GS ID (s)	GS11936
Title of Project	Solar power for rural Regions in Nigeria
Name of VVB	Carbon Check (India) Private Limited
Date and version of the report	version 01.1 dated 06/11/2023
Version number and date of the PDD applicable to this validation report	Version 3.1, dated 05/12/2023
Coordinating/Managing entity (CME)	atmosfair gGmbH
Host Country	Nigeria
Applied methodologies and standardized baselines	CDM Methodology: AMS-I.F.: Renewable electricity generation for captive use and mini-grid --- Version 05.0
Mandatory sectoral scopes	01
Type(s) of Design Change	<input type="checkbox"/> Temporary deviations from the registered monitoring plan, applied methodologies, standardized baselines or other methodological regulatory documents. <input type="checkbox"/> Corrections <input type="checkbox"/> Changes to the start date of the crediting period <input type="checkbox"/> Inclusion of monitoring plan <input checked="" type="checkbox"/> Permanent changes <input type="checkbox"/> Changes to the project design <input type="checkbox"/> Changes specific to afforestation and reforestation activities

Carbon CHECK	GS4GG Design Change Assessment Report	Revised: September 2021
--	---	---------

Figure 1: Outage profile in ParkRoad area

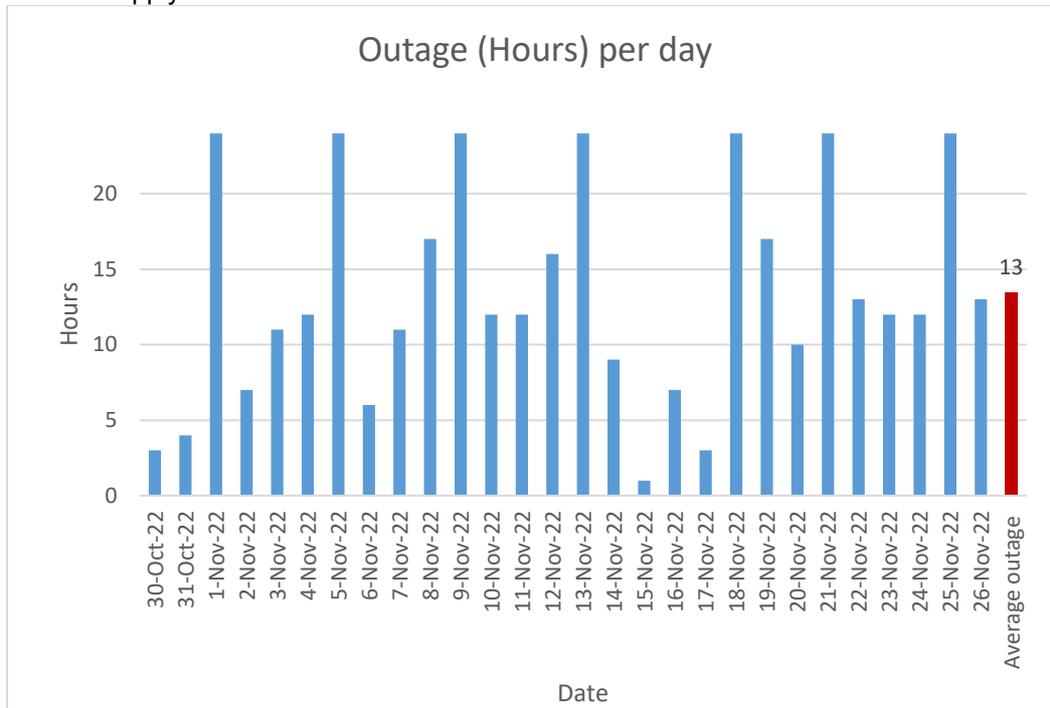
PD has found that there are numerous region across Nigeria that have electricity shortage from the National grid. PD has conducted an assessment of the existing demand, viability and feasibility for the prospective area and has submitted an example for Park Road area in Akwa Ibom State, which is included in the expansion zone. The energy demand and estimated daily electricity consumption of 37 customers and 2 schools is recorded has been submitted to VVB /06/ and also a excel file which contains the outage profile /05/ and confirms that the Park area experiences 13 hours outage. The data was collected between 22nd February to 16th March 2021 and also confirms that the Park Road receives electricity for a duration averaging of 5 hours/days where the daily outages surpass 50% of the available

hour. The documents were verified and the same has been confirmed by VVB which emphasizes the demand for electricity supply.
